HINCKLEY NATIONAL RAIL FREIGHT INTERCHANGE

The Hinckley National Rail Freight Interchange Development Consent Order

Written Statement of oral case at ISH6

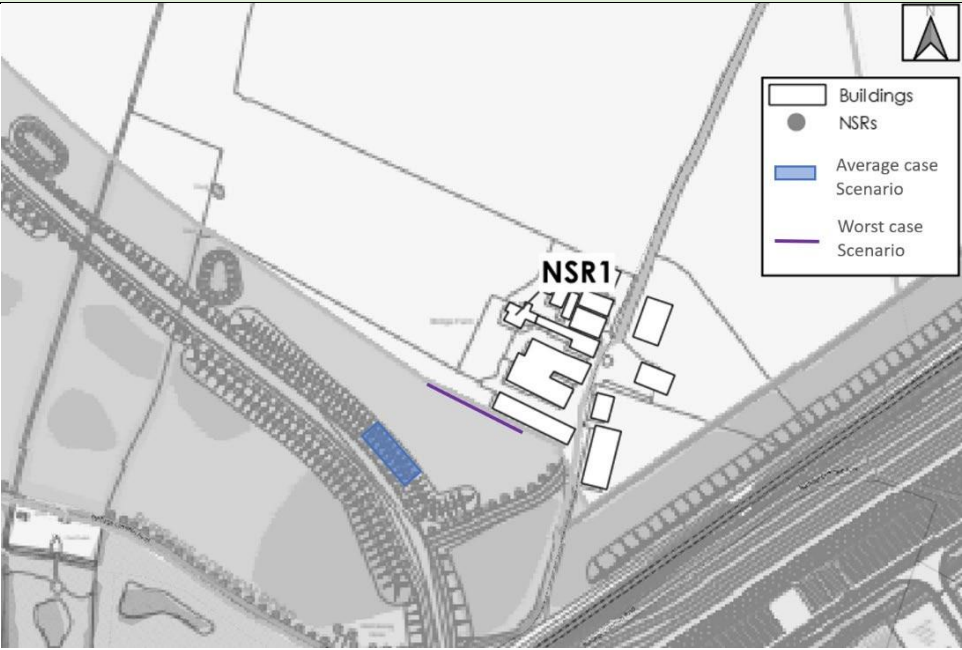
Agenda item	Matter	Applicant's submission
	<p>contours to use in lieu of attenuated real noise. In particular in relation to Mr Moore's evidence at rep 204 which does dictate eight points of concern in relation to the overstatement of road noise.</p> <p>Mr William David Moore stated that there is voluminous evidence that the applicant's road noise contours overstate road noise levels versus those measured by NMPs and should not be used in lieu of NMP measurements</p> <p>1. The applicant's own report states that the applicant's road noise model's sound levels are in excess of those measured by NMPs, as shown in the report's Table 10.51 and Paragraphs 10.226-10.228. For the purposes which the applicant was using their road noise model for at that time, that may have meant a robust assessment case. However, if the applicant attempts to use their road noise model to make definitive claims about ambient road noise levels, then the applicant's model doesn't present a robust assessment</p>	<p>1. The long-term noise levels measured at NMP1 and NMP2 are within 3 dB of the noise levels predicted by the 2019 baseline road traffic noise model. This is within accepted tolerances and shows good correlation between the measured and predicted noise levels. For reasons set out within paragraph 10.226, noise levels measured at NMP5 and NMP6 are less reliable.</p>

Agenda item	Matter	Applicant's submission
	<p>case, simply an incorrect one. The applicant was aware of that.</p> <p>1.1. The applicant's operational noise assessment uses the lowest day of background or ambient sound levels measured during each time period. Table 10.51 doesn't use the lowest day, which means the difference between the predicted level and the day with the lowest level is greater than the differences shown in Table 10.51. E.g. The difference at NMP1 for the daytime would be the predicted level (59 dB in Table 10.51) minus the lowest daytime level (53.6 dB in Table 10.43). This difference is 5.4 dB, greater than the 3 dB difference between predicted and measured sound levels in Table 10.51.2.</p> <p>2. NMP4's Saturday night-time measurements (which the applicant wrongly expunged) had ambient sound levels due to all sources of sound of 44 dB, as shown in the report's Table 10.23. This is 9 dB below the night-time ambient sound level which the applicant is</p>	<p>1.1 The analysis undertaken following ISH3 and detailed in Appendix F – Update to Noise Assessment Note (ref 18.7.6) provides an indication of the likely ambient noise levels in the vicinity of NSRs on Billington Road drawing on long-term data for the rail line and road traffic.</p> <p>This analysis shows that the noise levels measured at NMP4 are representative of the ambient noise levels at receptors and therefore the results and conclusions of the Noise and Vibration assessment remain valid.</p> <p>Notwithstanding the above, it is also worth noting that ambient noise levels used within the noise assessment are the lowest reported representative level over the assessment periods.</p> <p>2. This is incorrect, noise levels measured on Saturday night did not include rail movements, as detailed in paragraphs 10.106 to 10.108 in Chapter 10 Noise and Vibration (document reference 6.1.10A, REP4-039). Therefore, the noise levels do not include all sources of sound.</p>
